WALZEM PARTNERS BUSINESS PARK
PRELIMINARY OVERALL AREA DEVELOPMENT PLAN

Re: Walzem Partners Business Park POADP # 569

P.O.A.D.P REVIEW

Walzem Partners Business Park
Located on FM 78 at Walzem Road

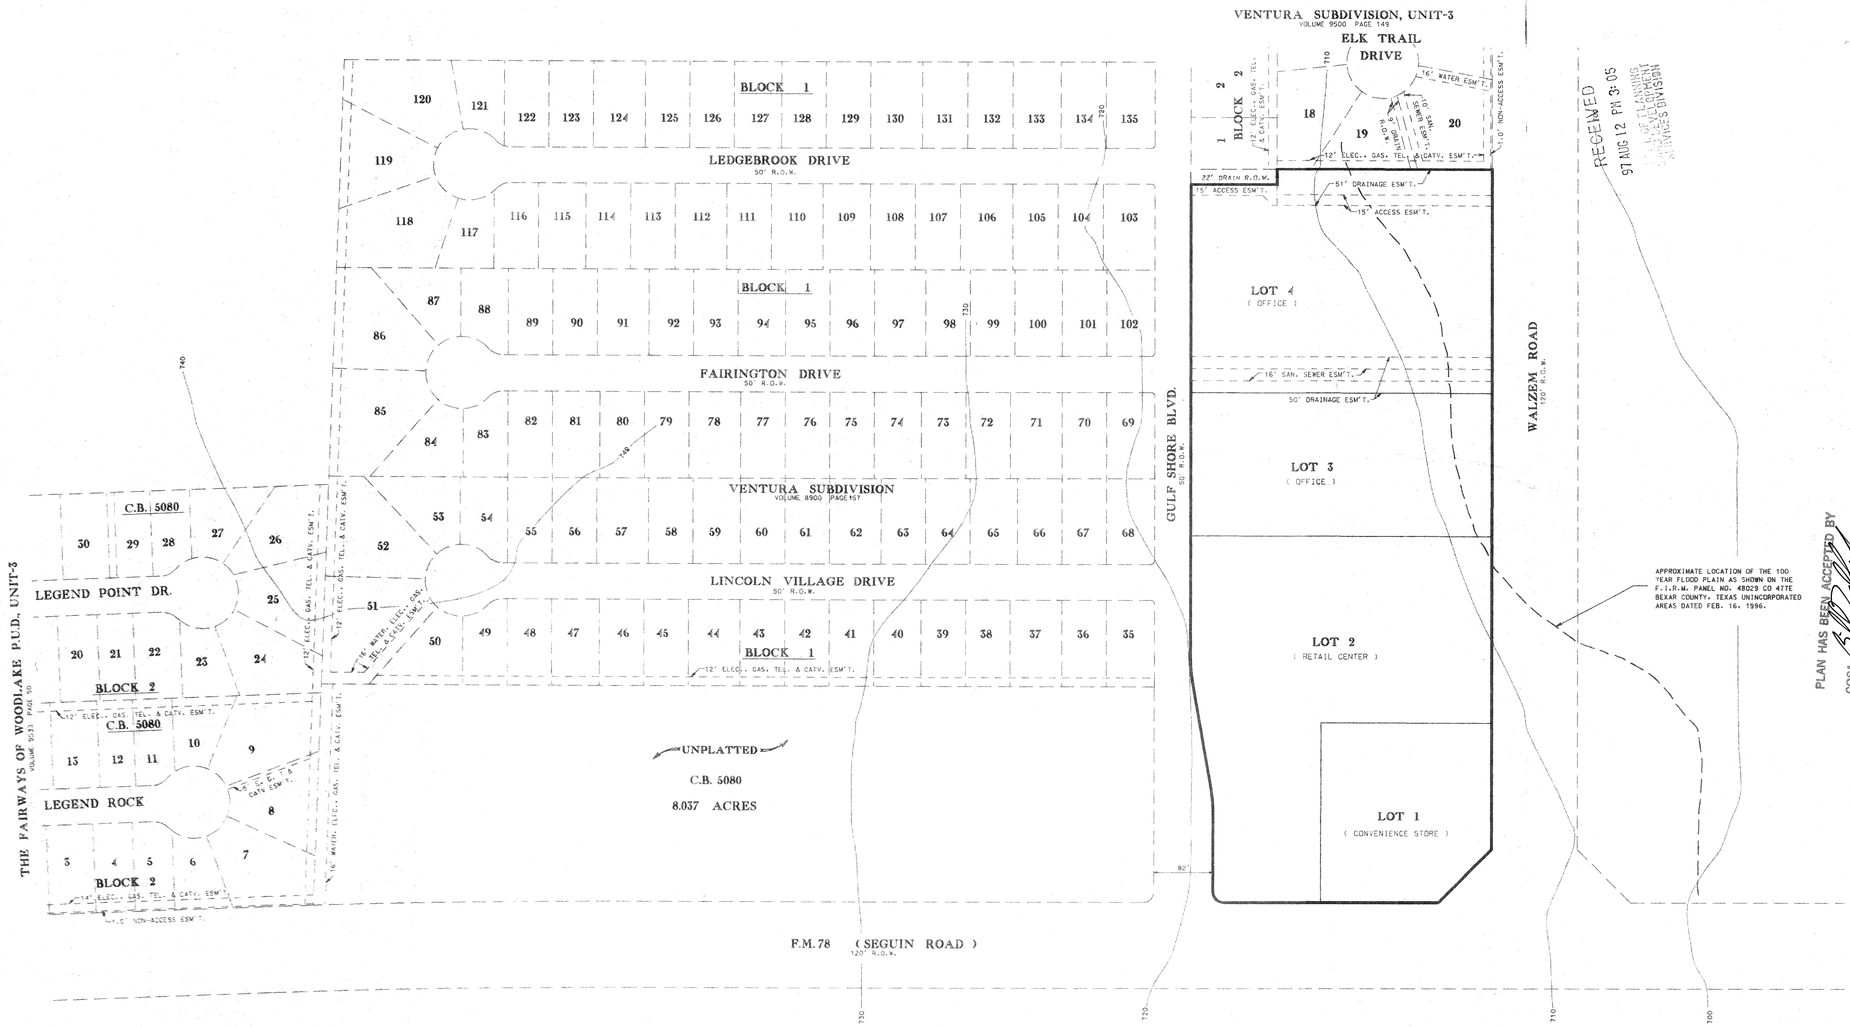
- If the proposed development is not platted in phases or units this POADP will not be valid.
- Access and R.O.W. issues along State facilities will need to be resolved with the Texas Department of Transportation (TXDOT). For additional information about these requirements you can contact TXDOT at 615-5814.
- Based on the topography, a Flood Plain Study and drainage review will probably be required during the platting process.
- This development may need to comply with tree preservation ordinance #85262. For additional information about these requirements you can contact Building Inspections at 207-7102.
- A 1" non vehicle access easement will need to be provided along Golf Shore Boulevard.

Comments: Drainage easements will be required and address during the platting process.
Will require Flood Study

P.O.A.D.P. Reviewed for:	Comments
Noise Mitigation	For residential development directly adjacent to State ROW, the developer shall be responsible for adequate set-back and/or sound abatement.
R.O.W. Requirements	A 50' R.O.W. flare is required at the intersection of Gulf Shore Boulevard and FM 78.
Access Limits/Restrictions	This development is eligible for a maximum combined total of two(2) access points along the overall FM 78 frontage. Locations will be as directed by "Regulations For Access Driveways to State Highways".
WPAP Requirements	None

- phasing
- curb cuts
- tree notes
- non access on Golf Shore
